CONSOLIDATED EDISON COMPANY OF NEW YORK, INC. INDIAN POINT NUCLEAR GENERATING UNIT NO. 3

SEVENTH SUPPLEMENT TO: PRELIMINARY SAFETY ANALYSIS REPORT

PREFACE

Supplement 7 to the Indian Point Unit No. 3 PSAR consists of responses to the AEC questions of November 20, 1968. The questions deal with the following areas:

FIGURE 3-1
Supplement 7

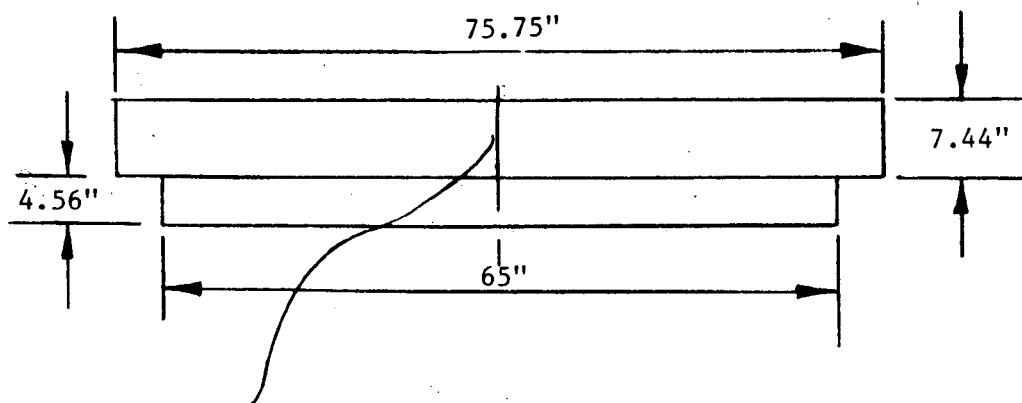
QUESTION 3

The primary coolant pump flywheels are shown in Figure 3-1. As for the pump motors, the most adverse operating condition of the flywheels is visualized to be the loss-of-load situation. The

following conservative design-operation conditions preclude missile production by the pump flywheels. The wheels are fabricated from rolled, vacuum-degassed, ASTM A-533 steel plates. Flywheel blanks are flame-cut from the plate, with allowance for exclusion of flame-affected metal. A minimum of three charpy tests are made from each plate in accordance with ASME specifications, to determine that each blank satisfies design requirements. An NDTT less than $+10^{\circ}\text{F}$ is specified. The finished flywheels are subjected to 100% volumetric ultrasonic inspection. The finished machined bores are also subjected to magnetic particle, or liquid penetrant examination.

FIGURE 5.4-1
Supplement 7

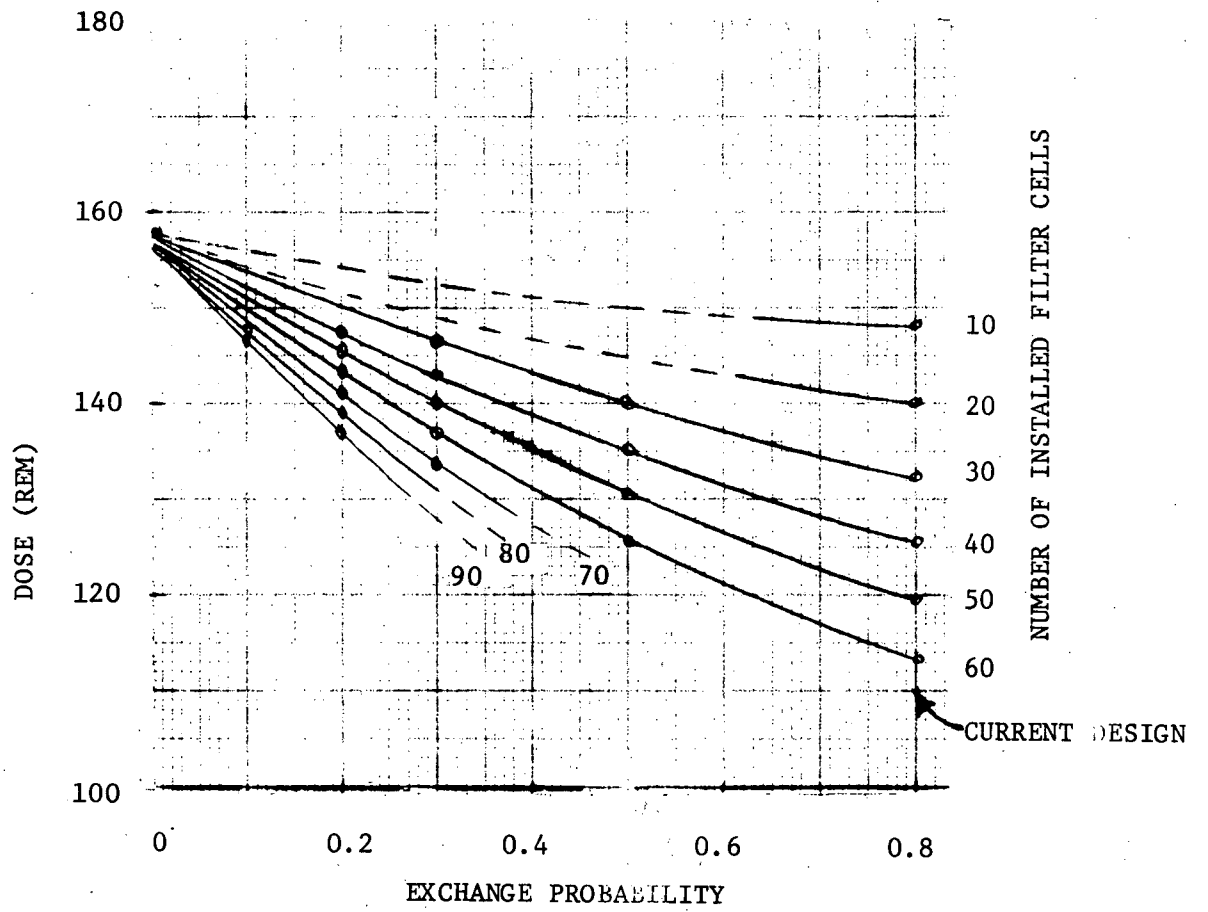
As discussed in our letter of February 19, 1968 and our meeting of November 6, 1968, the design basis accident doses evaluated by the staff do not meet the guideline dose levels recommended in 10 CFR 100. Please discuss the manner in which you intend to diminish these doses. If added equipment or modified assumptions are anticipated, please describe and provide an evaluation of the changes.

The analyses presented in this section demonstrate that the amount of radioactivity released to the environment in the event of a loss-of-coolant accident do not result in doses which exceed the limits specified in 10 CFR 100. In order to show more clearly the influence of the charcoal filter effectiveness on off-site inhalation doses, the dose resulting from iodine in organic form has been calculated separately as a function of filter efficiency. The doses at the site boundary and at the low population zone are presented in Figures 5.4-1 and 5.4-2. For the planned design, sixty filter cells will be installed, and two of the five installed filter units are assumed to be unavailable at the time of the accident. With a filter efficiency of 50% (exchange probability of 0.50) the two hour site boundary dose from organic iodine is 126 rem, and the 30 day dose at the low population zone is 136 rem.
